Below is our answer to comments from reviewer #1 and #2. In red is our answer as detailed in our Author Comments. In purple is the modification performed in the manuscript. All line numbers refer to the manuscript in track changes mode, as found in the present document below our answer to reviewers.

REVIEWER #1

Figure R1. Observed and simulated daily soil water content at US-WBW.

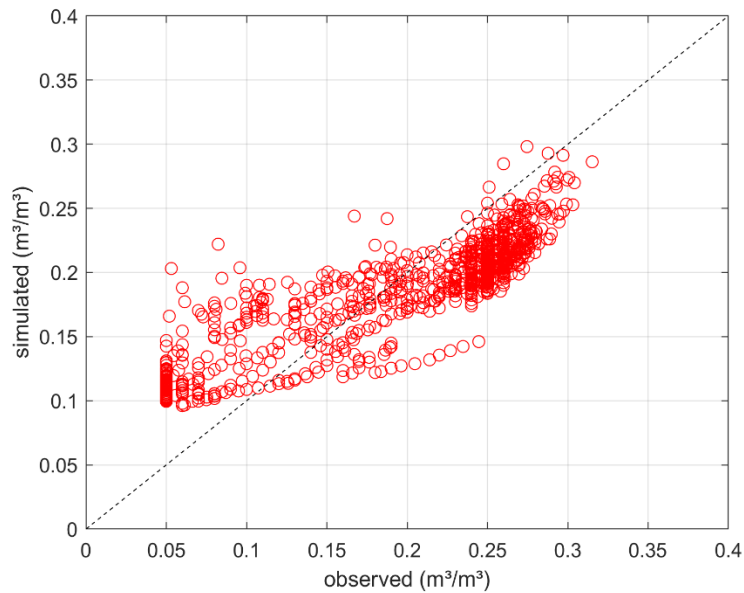
Figure 6: The deviations between the model and the observed soil water content value appear a little too large for an NSE of 0.61. Please double check.

RESPONSE: We double-checked this number and the NSE is 0.61 when comparing observed and simulated daily soil water content at US-WBW. Figure R1 shows that the performance of HGS-MEP using a scatterplot, which shows moderate performance of HGS-MEP in line with a NSE value of 0.61.

Figure 5. Observed and modeled hourly average terrestrial evaporation at US-Wkg (climate: semiarid, vegetation: grassland), b) US-Ton (climate: Mediterranean, vegetation: woody savanna) and c) US-WBW (climate: temperate, vegetation: deciduous broadleaf forest).

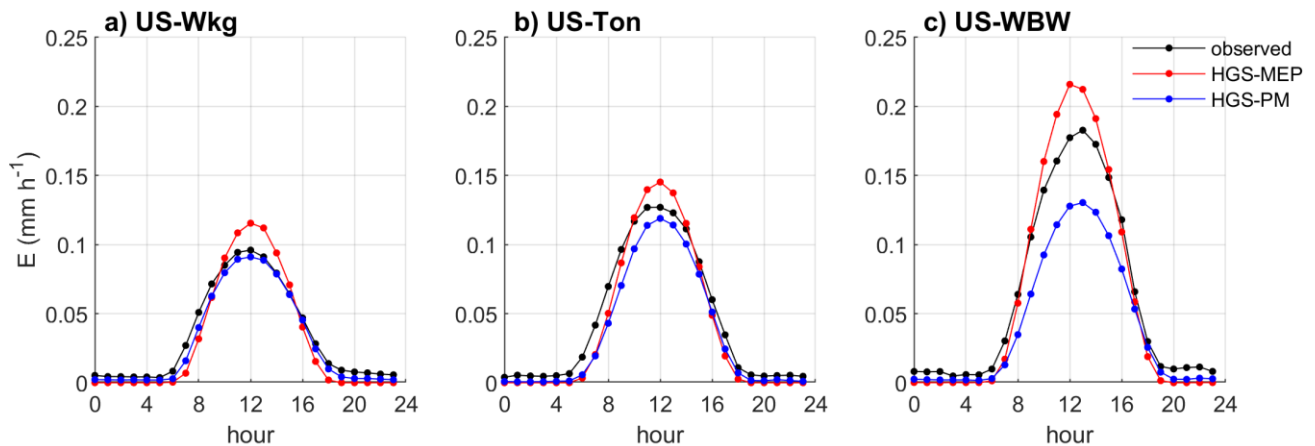
M4): The proposed results underpin very much that the HGS-MEP perform superior. But does it perform acceptable? The latter requires definition of a model acceptance threshold a priori, e.g. of $NSE > x$. At US-TON the soil water content and ET are underestimated by -5%, -11%. So where did the water go? The authors evaluate their model using daily mean values. I would be interested in seeing the model performance at the diurnal scale.

RESPONSE: We agree that this would be a very interesting addition to the manuscript. We will add a section describing the performance of the models at the diurnal scale, as depicted in figure R1. HGS-MEP performed well in describing the diurnal pattern of variation in terrestrial evaporation, although we observed an overestimation of maximum values at mid-day. In addition to the figure, we will also add a table with performance metrics to quantify the ability of the models to capture the diurnal variation in terrestrial evaporation.

MODIFICATION: We added a paragraph to discuss the performance of HGS-MEP at US-Ton (p.19, lines 17-31) and its relation to the rooting depth. Moreover, we added results regarding the performance of models at a diurnal scale. We added Figure 5 which shows the observed and modeled hourly average terrestrial evaporation at the three sites. We also added Table 6 with performance metrics computed at a half-hourly time scale. We present these results for each site (p.11 line 43, p.5 line 33, p.17 line 17). We also added a paragraph regarding these results in the discussion (p. 19 lines 31-40).
